Attachment 1:	Boffa Miskell 15 March 2019: Canterbury Coal Mine RFI Response: Ecological Impact Assessment Report
Attachment 2:	Boffa Miskell 23 November 2017: Canterbury Coal Mine Tara Stream Sediment Retention Pond Ecological Assessment
Attachment 3:	Boffa Miskell 12 January 2017: Canterbury Coal Mine Ecological Significance Assessment of Tara Stream Wetland, the Northern Elf and Bush Gully Stream
Attachment 4:	JH Rekker Consulting Limited 16 December 2019: Response on Hydrological Matters
Attachment 5:	CCR Discharge to Land Resource Consent Application
Attachment 6:	Tips Dams and Voids Principal Hazard Management Plan (PHMP)
Attachment 7:	Ground or Strata Instability PHMP
Attachment 8:	CCO2tele Water Quality Monitoring Results

#	Further Information Request	Response
1	Please provide a map identifying all individual seepages/wetlands located inside the MOA (Mine Operating Areas) and within the zone of influence. This map should include the seep/wetland boundary and identify the location of seeps/wetlands that may have already been removed from any location within the MOA.	<p>An assessment of the effects of mine operations on the ecological values has been prepared by Boffa Miskel

Figure 12: Water Quality Monitoring Sites

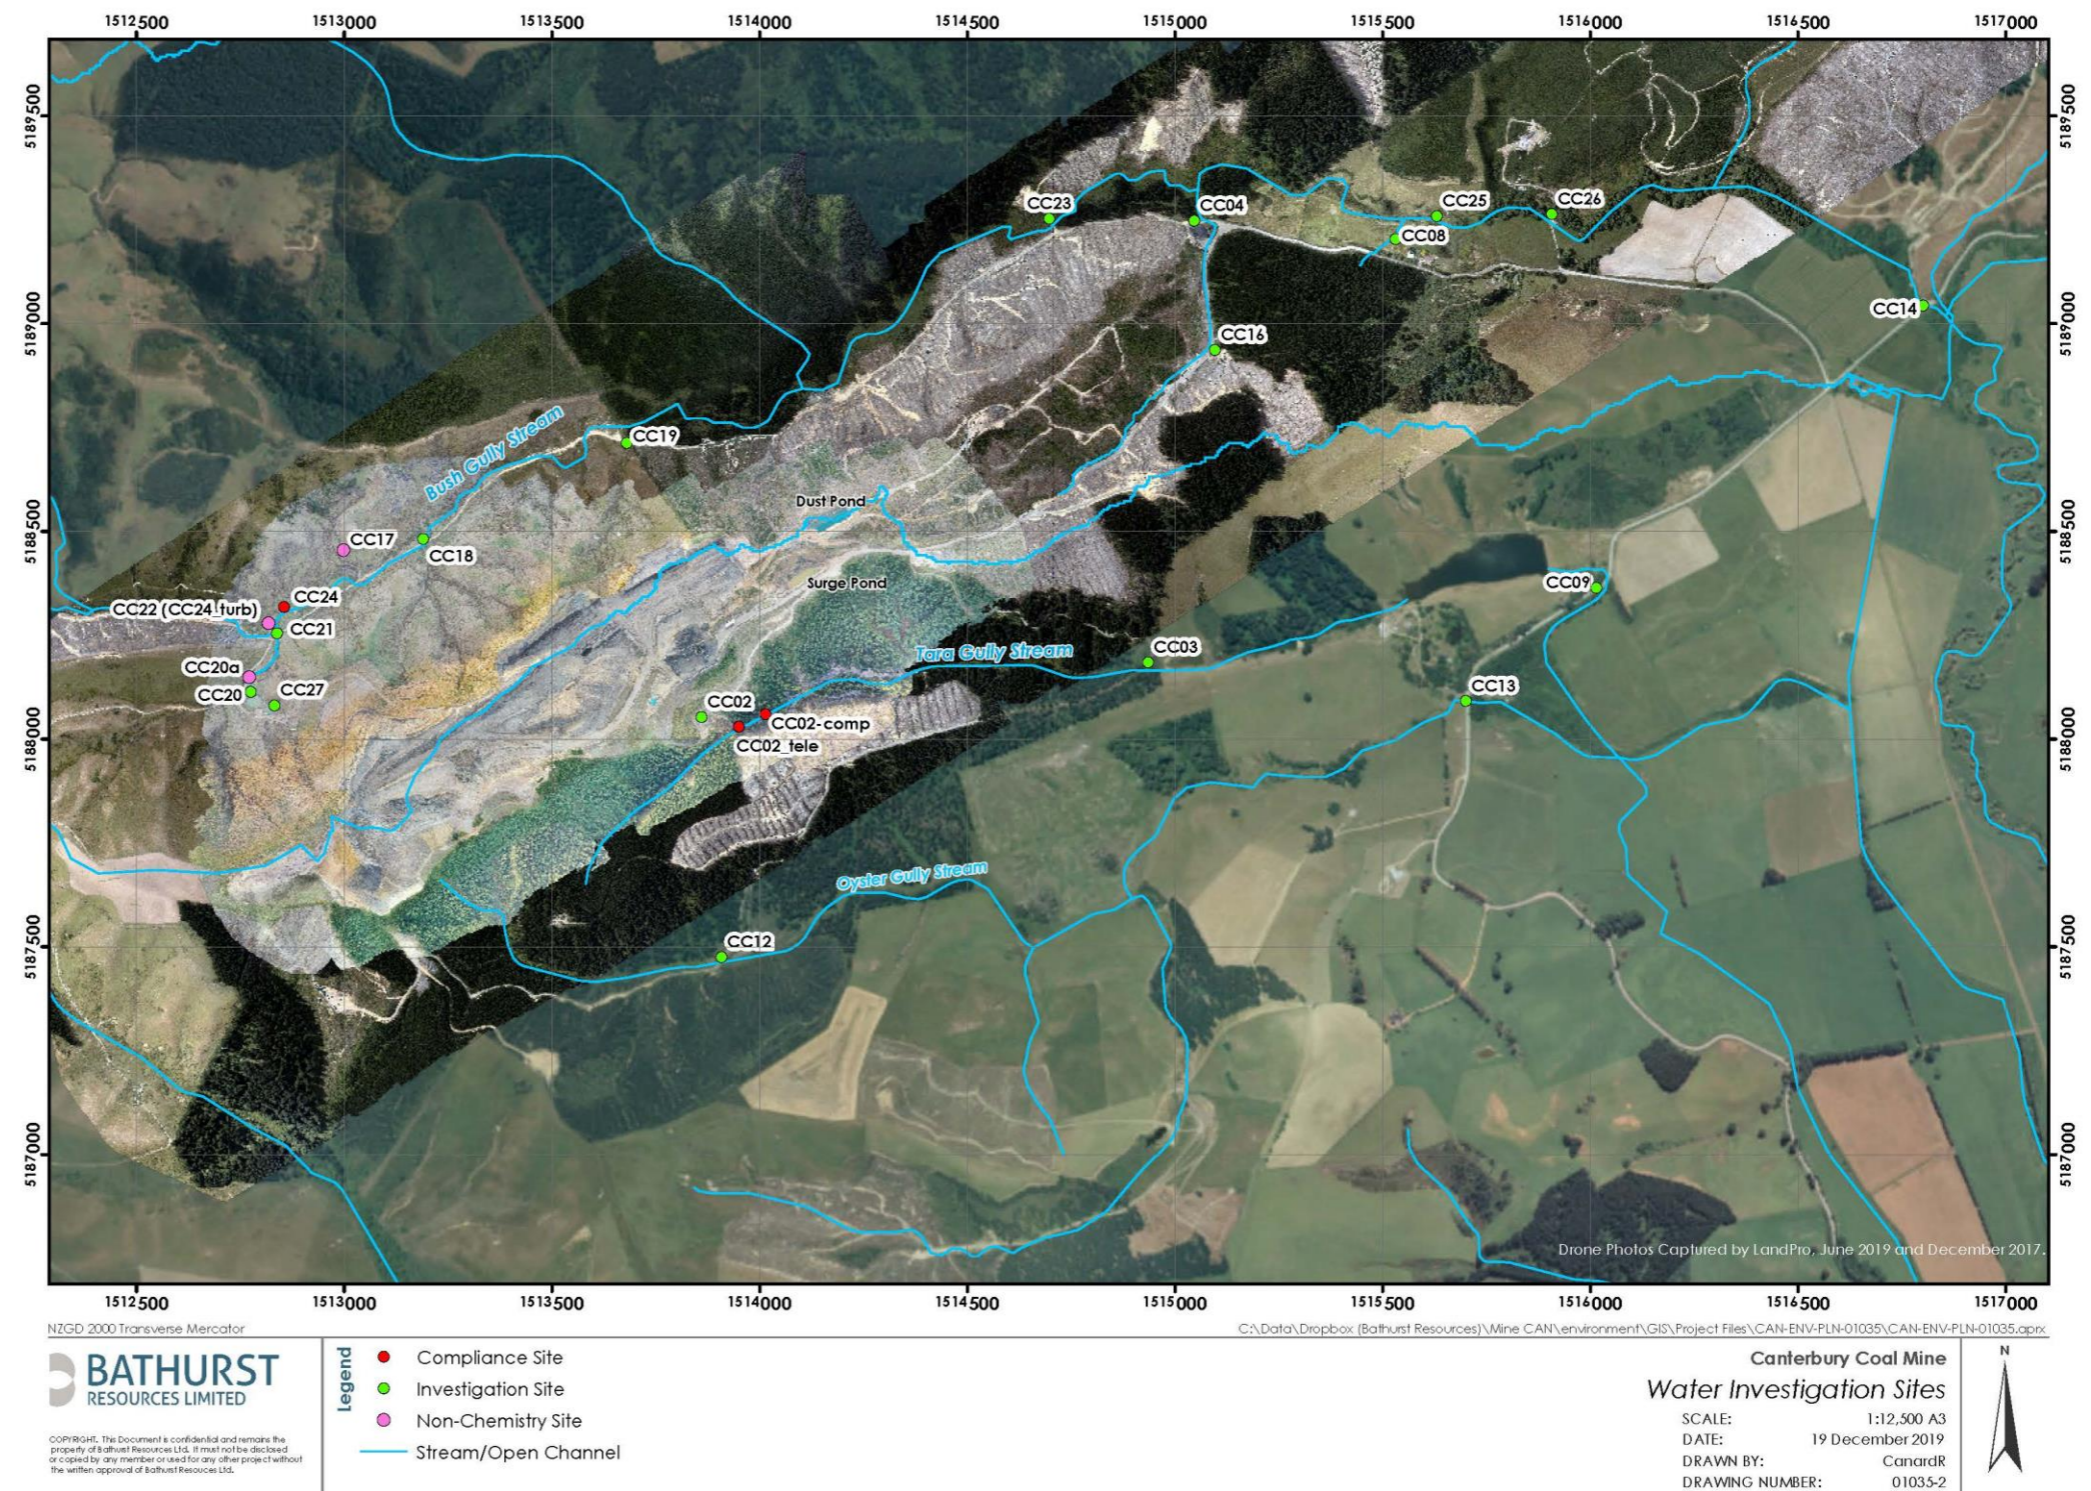
6	<p>Monitoring at the exit of Pond 2 in Tara Stream is largely an “end-of-pipe” type discharge point. This is an appropriate “discharge” monitoring type site for a large mine-site, but there should also be a monitoring site demonstrating the effects after such discharges have equilibrated/stabilised in the environment and therefore their effects on the natural environment. So there should be a monitoring site some distance downstream, but not as far as below the forestry. Can the application give some consideration of an appropriate site, and appropriate monitoring?</p>	<p>As set out in the EMP, an extensive water management system is in place at the site. In addition to the monitoring and compliance site CC02, monitoring is already undertaken at other sites as shown in Figure 12 below:</p>

We would suggest that BCL monitor at CC03, being a site beyond the mixing zone and report these findings annually, along with a discussion on the longitudinal water chemistry in Tara Stream in the annual water monitoring report (see condition 24 CRC170541). This monitoring however should not be used to for enforcement action purposes.
